TITLE	PARTIAL MEZZANINE/LOW ROOF FRAMING PLAN - AREA B (SEQ-1)		
MADE BY	DATE	CONTRACTOR	JOB No.
PDS	11/30/2020		20028
CHKD BY	DATE	ARCHITECT	ENGINEER
JSY	11/30/2020		
			SHEET NO.
			1E1
			REV.
			A

**PARTIAL MEZZANINE/LOW ROOF FRAMING PLAN @ AREA-B (SEQ-1)**  
 (REF: S2.2 & 1/A1.3)  
 [TOP OF STEEL ELEVATION 114'-0 1/2" U.N.O.]

PARTIAL HIGH ROOF FRAMING PLAN @ AREA B (SEQ. 1)  
(REF: S3.2 & 1/A4.1)

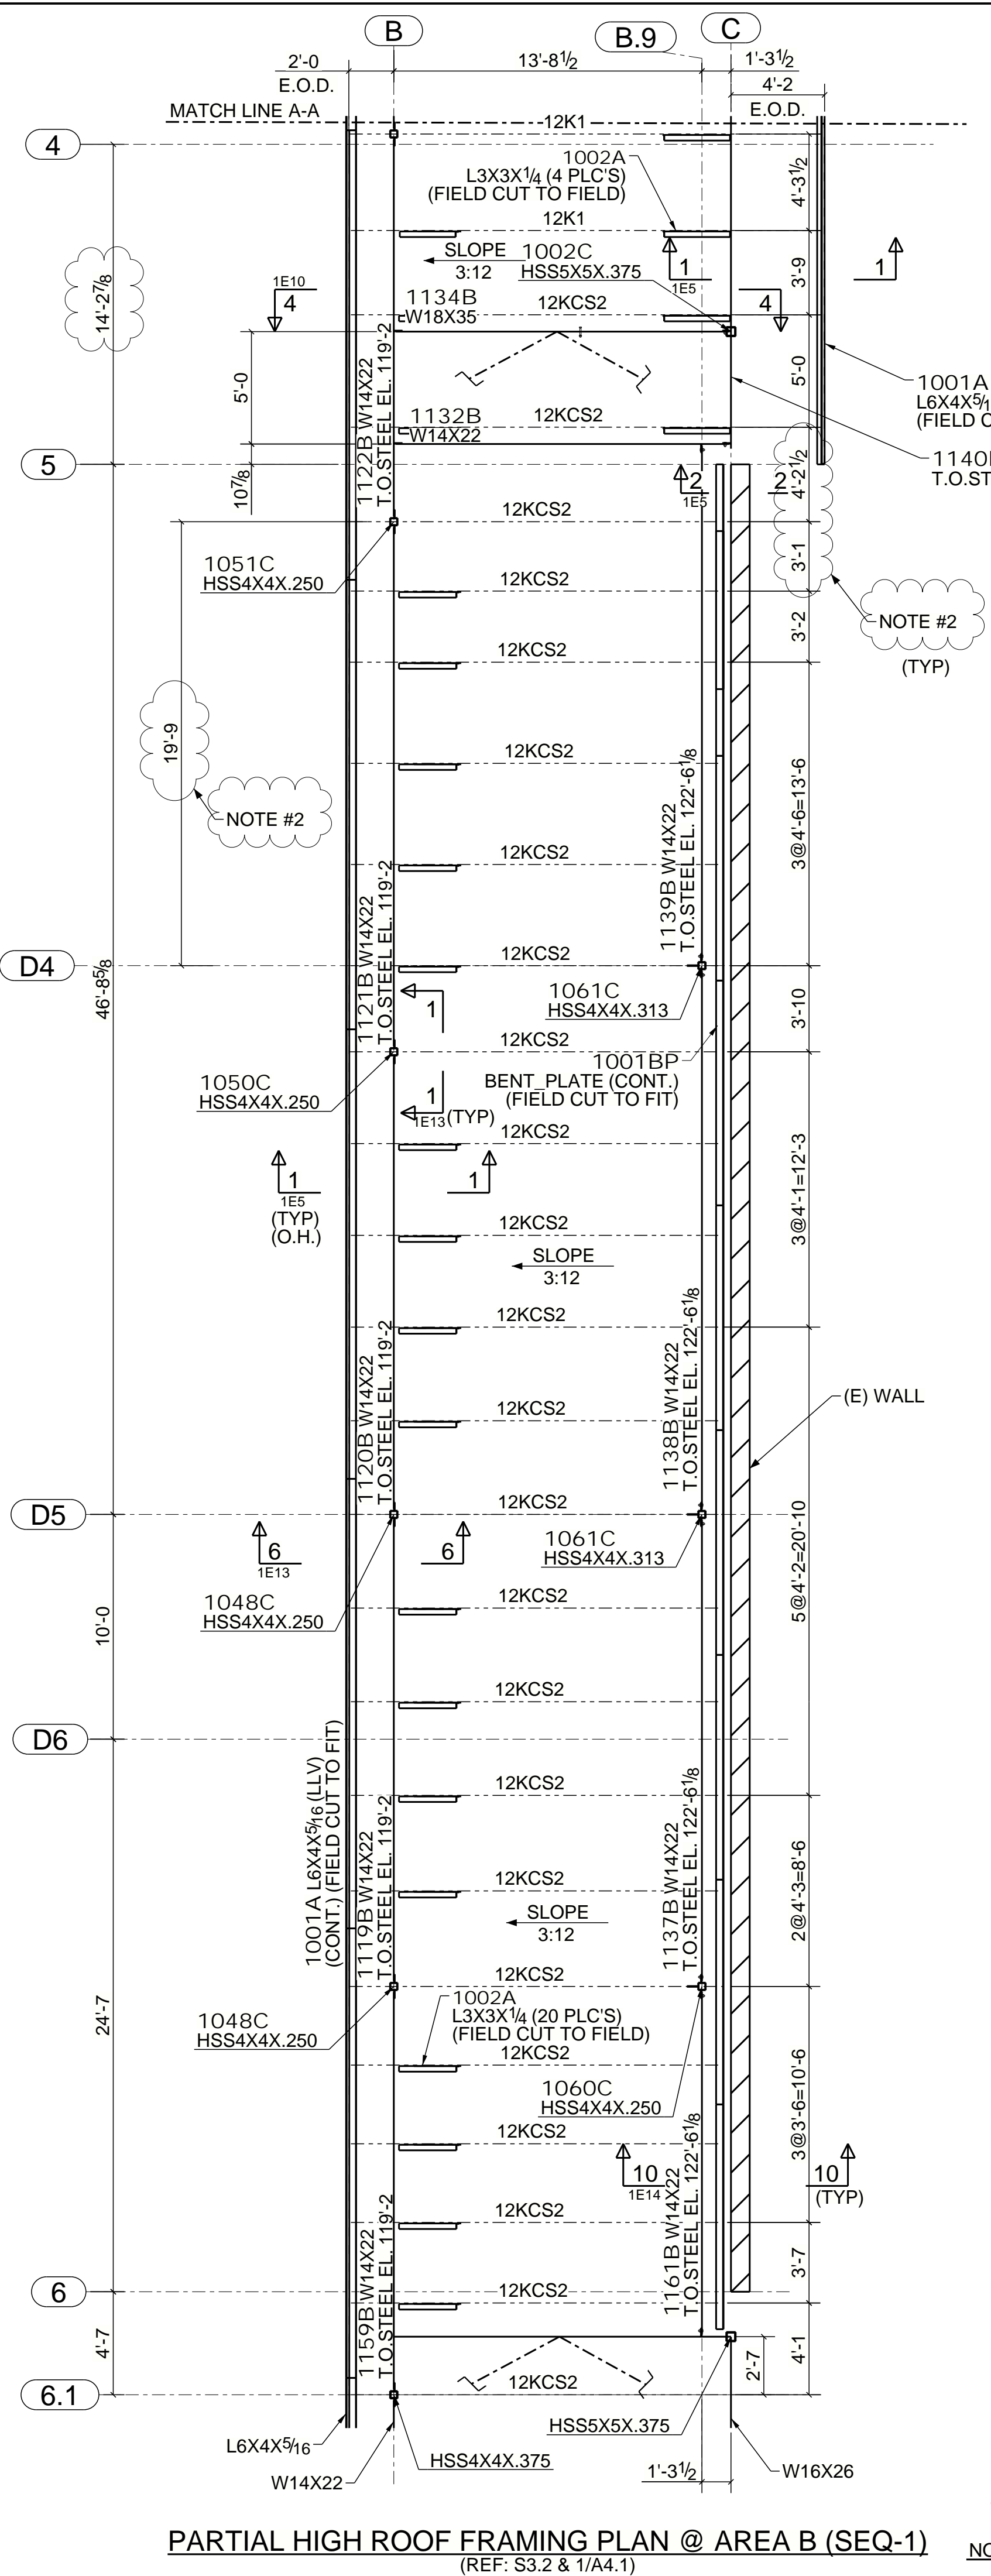
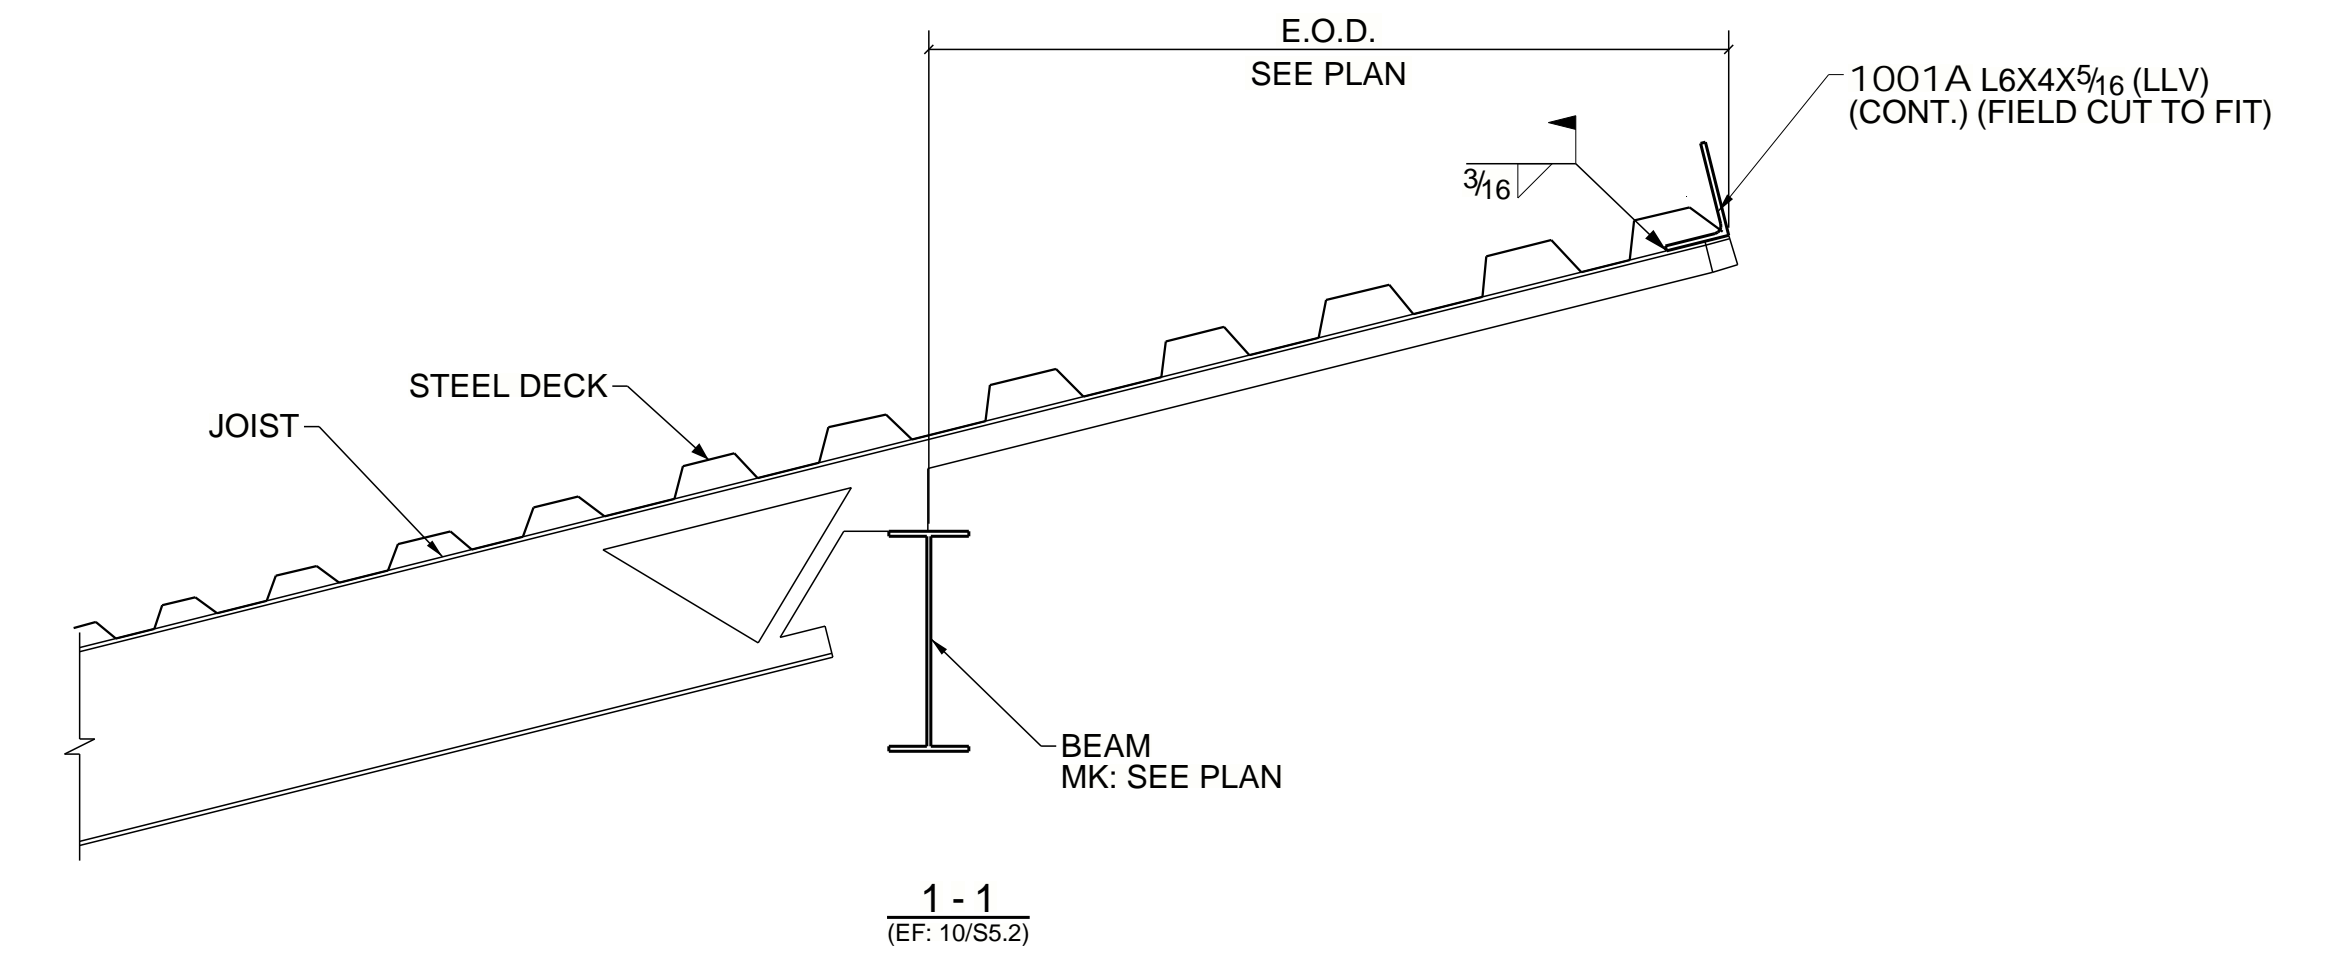
APPROVER NOTES:-  
 NOTE #1:- THERE IS CONFLICT IN THIS COLUMN LOCATING DIMENSION STRUC. PLAN S2.2 SHOWS THIS COLUMN LOCATED AT 24'-2" FROM GRID LINE-2. BUT PLAN S3.2 SHOWS COLUMN LOCATED AT 24'-2 1/2" FROM GRID LINE-2. CURRENTLY WE HAVE FOLLOWED 24'-2" AS PER PLAN S2.2 AND FOLLOWED JOIST SPACING 4'-11 1/2" & 5'-0 1/2". PLEASE VERIFY/SUGGEST.  
 NOTE #2:- THERE IS CONFLICT IN THIS COLUMN LOCATING DIMENSION STRUC. PLAN S2.2 SHOWS COLUMN LOCATED AT 19'-9" FROM GRID LINE-D4. BUT PLAN S3.2 SHOWS COLUMN LOCATED AT 19'-8 1/2" FROM GRID LINE-D4. CURRENTLY WE HAVE FOLLOWED 19'-9" AS PER PLAN S2.2 AND FOLLOWED JOIST SPACING 3'-1" & 4'-2 1/2" INSTEAD OF 3'-0" & 4'-3". PLEASE REVIEW/CONFIRM.
